MERCUISER SERVICE BULLETIN

Number: 70-16

Date : 8/14/70

Figure 1. Exhaust Tube Location

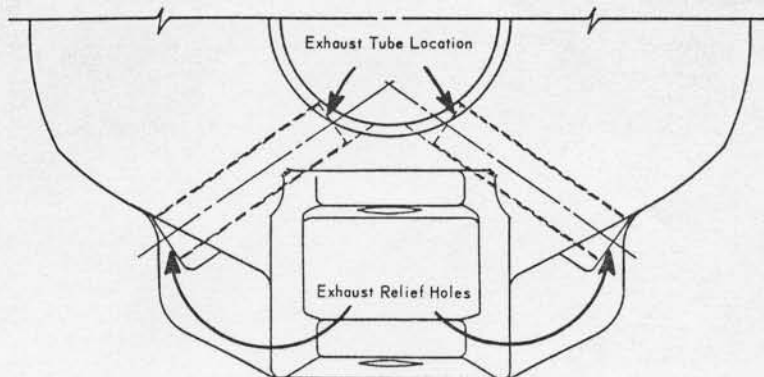
Some gimbal housings have been found leaking thru the casting near the exhaust relief holes (located on bottom of housing near the exhaust elbows). To correct this problem, coat the sides of each hole with sealer (C-92-52238-1) and insert one tube (C-32-59563A1) into each exhaust relief hole as shown in Figure 1.
